ASHTON COAL UNDERGROUND
SUBSIDENCE MANAGEMENT PLAN VARIATION
LONGWALL/MINIWALL 9

ASHTON COAL SUBSIDENCE MANAGEMENT PLAN
VARIATION
LONGWALL/MINIWALL 9
QUALITY CONTROL SHEET

Figure 1 Proposed Pikes Gully LW/MW 9 Variation - Copy of Plan 1A (A-4071)

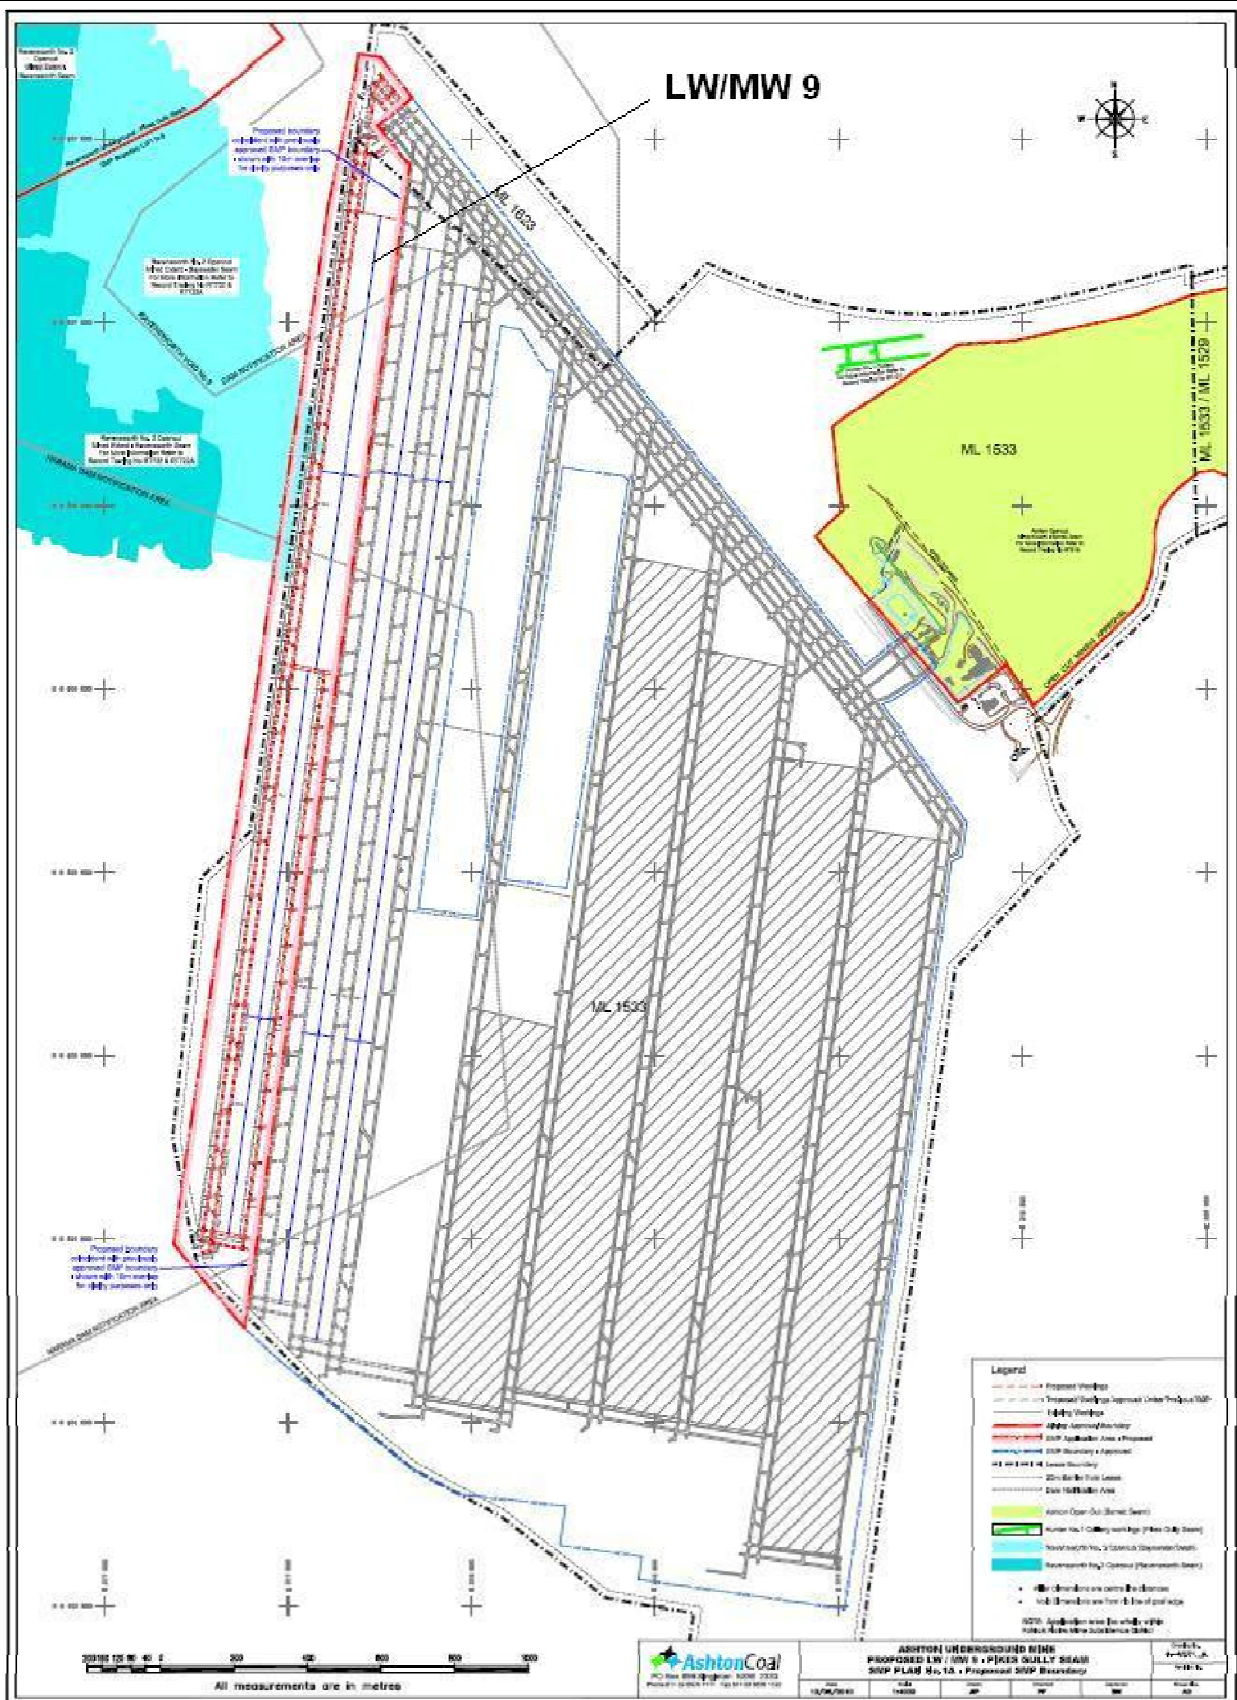
- Mine Design:-
 - Relocation (to that previously described in LW/MW 5-9) of LW/MW 9 by a distance of 50m from the boundary of the Bowmans Creek alluvium (Figure 1);
 - Relocation of cut-throughs in first workings for LW/MW 9 consistent with current mining sequencing (i.e. 150m pillars and pillar layouts configured for equipment specifications); and
 - Inclusion of a minimum 2.5m setback from the 20m barrier to the western lease edge.
- Groundwater:-
 - Minor variations that were approved by the DOP, and accepted by NOW, in DA 309-11-2001-i MOD 4. That is, for LW/MW 9, with respect to the LW 5-6 and MW 7-8 SMP, the predicted groundwater inflow rates are marginally greater than previously predicted, there will be negligible additional groundwater level drawdown and only minor reduction in baseflow to Bowmans Creek. The impacts are consistent with the original LW/MW 5-9 application.

- Relocation (to that previously described in LW/MW 5-9) of Longwall 9 startline by a distance of 50m from the boundary of the Bowmans Creek alluvium (Figure 1);
- Relocation of cut-throughs in first workings for LW/MW 9 consistent with current mining sequencing (i.e. 150m pillars and pillar layouts configured for equipment specifications); and
- Inclusion of a minimum 2.5m setback from the 20m barrier to the western lease edge.

Issue	Description	Action / Timing	Reference (page)
1. Mine Plan	Relocation of Longwall 9 within the Pikes Gully Seam by a distance of 50m from the boundary of the Bowmans Creek alluvium (in accordance with Condition 3.18A of Schedule 2 of DA 309-11-2001-i).	LW 9 is pulled back 50m and the updated Mine design is included for approval in the SMP Variation for LW/MW 9.	2
	Cut-through locations adjusted to reflect current mining sequences (i.e. 150m pillars and pillars layouts configured for equipment specifications).	The updated Mine design is included for approval in the SMP Variation for LW/MW 9.	2
	Ensure a 20m Barrier between workings and Lease Boundary	The Mine design incorporates a minimum 2.5m setback from the 20m barrier to ensure compliance. The updated Mine design is included for approval in the SMP Variation for LW/MW 9.	2
